**MANDATORY****MTL-52-02****TITLE**

DOORS - CABIN ENTRY DOOR HOOK REPLACEMENT

The cabin entry door hooks may have been improperly CAD plated or improperly manufactured.

This service document provides parts and instructions to inspect the existing cabin entry door hooks and replace the two cabin entry door hooks as necessary.

Figure 1. Cabin Entry Door Hook Location (Sheet 1)

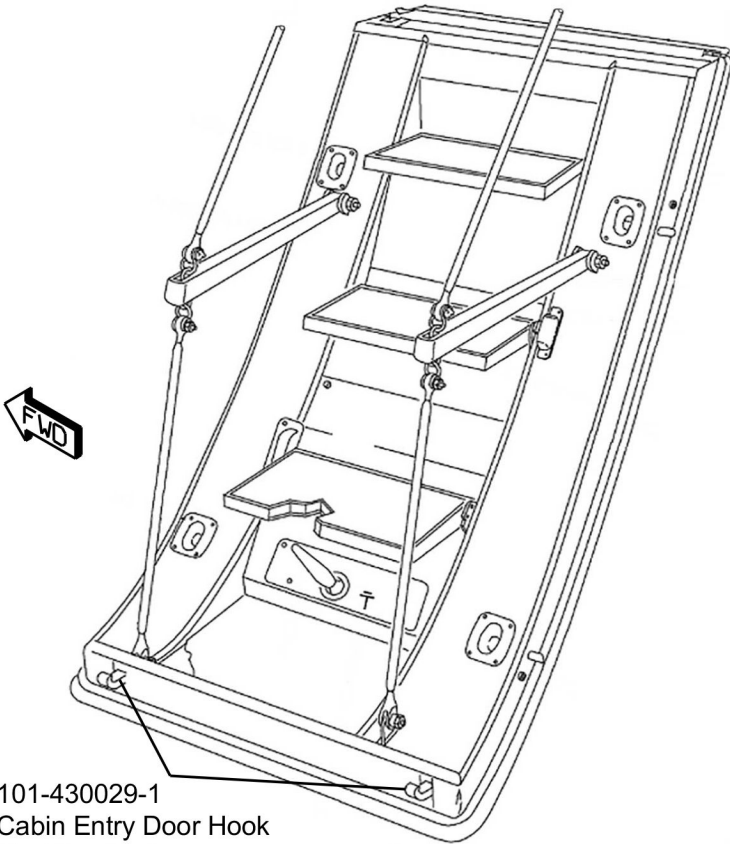
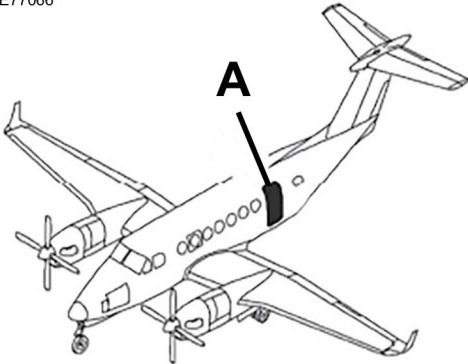
3. (Refer to Figure 1, Sheet 1.) Replace the 101-430029-1 Cabin Entry Door Hook as follows:
  - A. Remove the 101-430029-1 Cabin Entry Door Hook that does not have the inspection stamp.
  - B. Install the new 101-430029-1 Cabin Entry Door Hook.
  - C. Depending upon the airplane model, do the Cabin Entrance Door/Latch Mechanism Adjustment Test.
    - (1) Once the 101-430029-1 Cabin Entry Door Hooks have been set, apply U074040 (Loctite 222MS) Adhesive to the threads of the 101-430029-1 Cabin Entry Door Hooks.
4. Remove the maintenance warning tags and connect the airplane battery and ground power unit.
5. Do the Cabin Pressurization Test.
6. Make an entry in the airplane logbook that states compliance and method of compliance with this service document.

101-430029-1  
 Cabin Entry Door Hook  
 (As Required)

**NOTE:** The airplane locator is a B300, yet the location of the 101-430029-1 Cabin Entry Door Hooks is the same across all models.
